STAFF RECOMMENDATION
116 Mockingbird Road
April 18, 2012

Application: New construction – Accessory structure
District: Cherokee Park Neighborhood Conservation Zoning Overlay
Council District: 24
Map and Parcel Number: 10312023900
Applicant: Douglas Linfert, Owner
Project Lead: Sean Alexander, sean.alexander@nashville.gov

Site Plan 116 Mockingbird Road

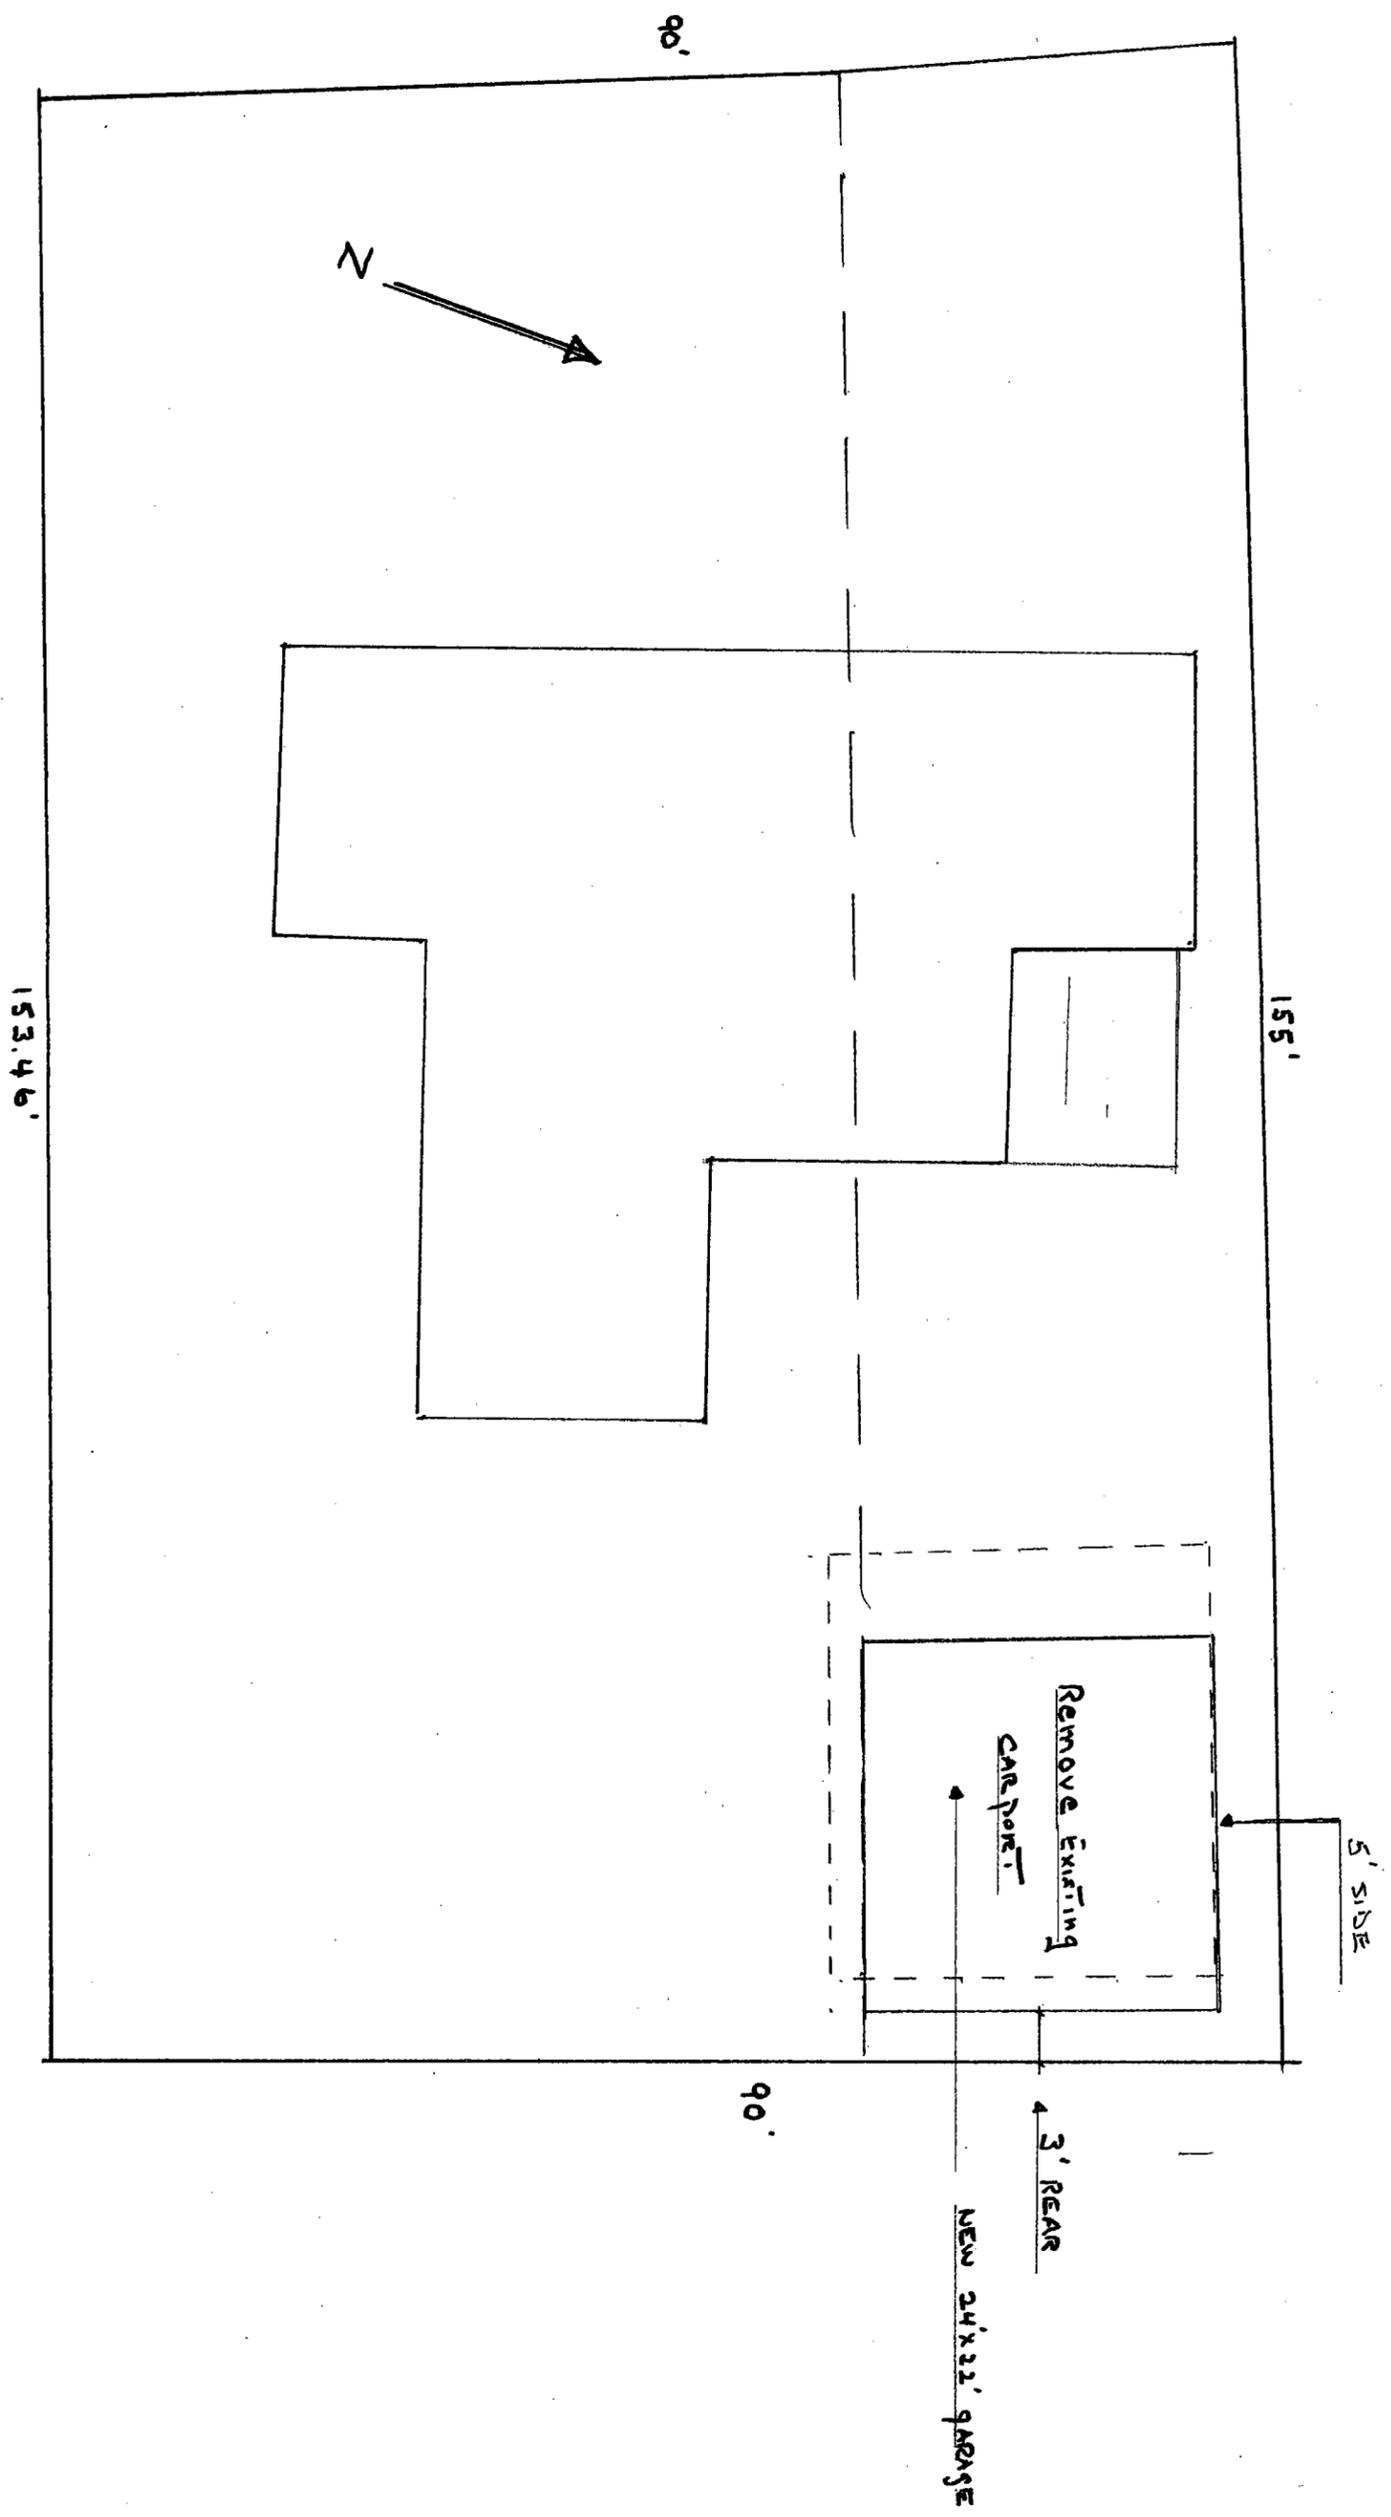
The structure will be located behind the primary structure, three feet (3') from the rear property boundary and five feet (5') from the left side boundary. This location is appropriate and meets the bulk setback regulations and guideline II.B.1.c.
